## CERTAIN 2013-2015 MODEL YEAR FLEX, MKS, MKT, TAURUS AND POLICE INTERCEPTOR SEDAN VEHICLES — FUEL PUMP CONTROL MODULE INSPECTION AND REPAIR

## **NEW!** SERVICE PROCEDURE

FIGURE 1

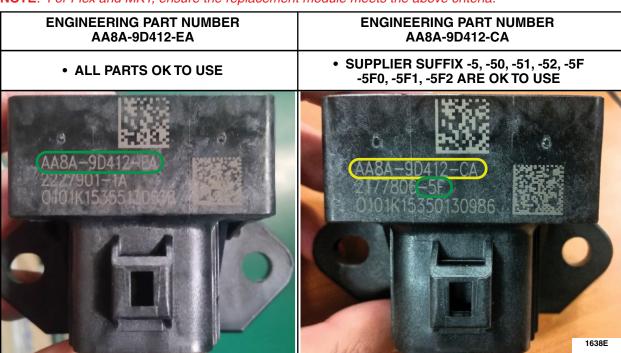
- 1. Remove the fuel pump control module. Please follow the Workshop Manual (WSM) procedures in Section 303-04.
- 2. Inspect the engineering part number and, if necessary, the supplier part number suffix on the fuel pump control module. See Figure 1.
  - If either (A) the engineering part number is AA8A-9D412-EA, OR (B) the engineering part number is AA8A-9D412-CA and the supplier part number suffix is -5, -50, -51, -52, -5F, -5F0, -5F1, or -5F2, module replacement is not required. Reinstall the original fuel pump control module. Please follow the WSM procedures in Section 303-04. No additional service is required.
  - If the module does not meet either criteria, proceed to Step 3.
- 3. Install a new fuel pump control module. Please follow the WSM procedures in Section 303-04.

NOTE: For Flex and MKT, ensure the replacement module meets the above criteria.
